INITIAL FIRE SAFETY INSPECTION REPORT

LIBERTY KNITWEAR LTD. (Extension)

RSC ID: 24761

Fire Safety Inspection Report

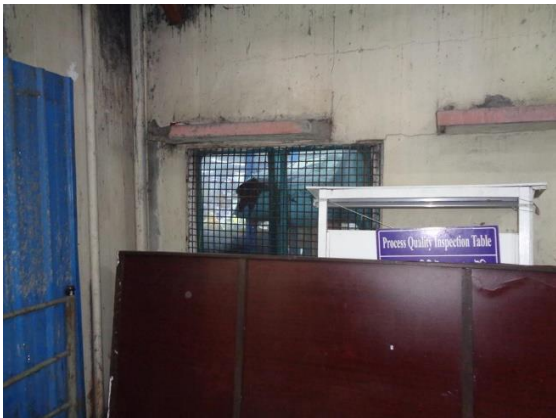
F-4	Fire Rated Construction	Penetrations and Opening through floor/ceiling assemblies are found unsealed. Location(s): ETP Building	Seal all penetrations and openings in floor/ceiling (full thickness of the floor/ceiling) assemblies by fire rated materials to maintain the fire resistance rating of 3 hr. Provide a minimum 3-hr fire rated shaft to separate the utility risers from each floor if required.	Within 3 months

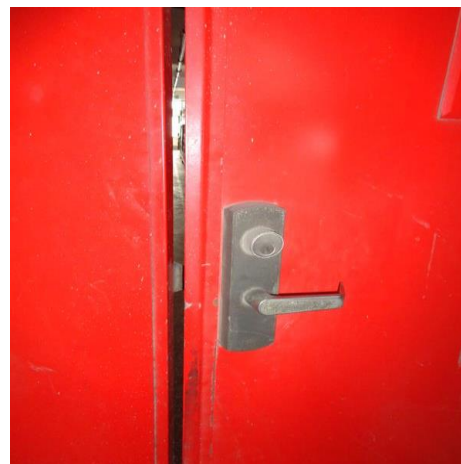
F-5	Fire Rated Construction	Interior building exit discharge has not been arranged as per 6.17.3 of RSC Technical Guidelines Standard. Location: ETP Building and Canteen Building.	A maximum of 50 percent of the number and capacity of the exit enclosures can discharge through areas on the level of exit discharge where all of the following are met: (1) Automatic sprinkler protection is provided throughout the level of exit discharge or portion of the level of discharge where separated from non sprinklered portions of the floor by fire barriers with the same fire resistance rating as the exit enclosure. (2) The interior discharge is not through a storage or hazardous occupancy. (3) The entire area of the level of exit discharge is separated from areas below by construction having a fire resistance rating not less than that required for the exit enclosure. (4) The way to the exterior shall be free and unobstructed and shall be readily visible and identifiable from the point of discharge of the interior exit. Or Provide 2-hr fire-rated exit passageway leading directly outside.	Within 3 months
